CCEA MOBA

C C E A M O B A

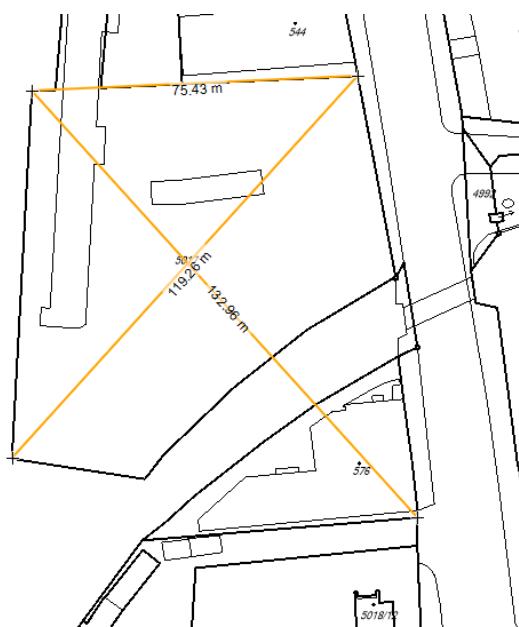
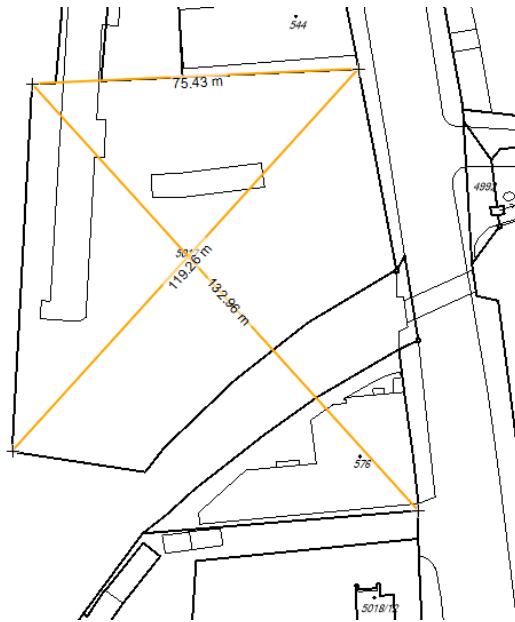
22 / Mohli byste zobrazit některé rozměry v katastrální mapě, aby bylo možné ověřit správné měřítko importu dwg souboru?

22 / Please could you show on the cadastral map a figured dimension, ie a length of the site boundary, to ensure that the cadastral dwg file is imported at the correct scale.

Níže zobrazeny jsou rozměry parcely č. 5017. Skutečné rozměry lze také ověřit např. na www.nahlizenidok.cuzk.cz

We are providing the cadastral map with the dimensions of the plot no. 5017 next to the competition site.

The real dimensions can be easily checked on i.e. www.nahlizenidok.cuzk.cz
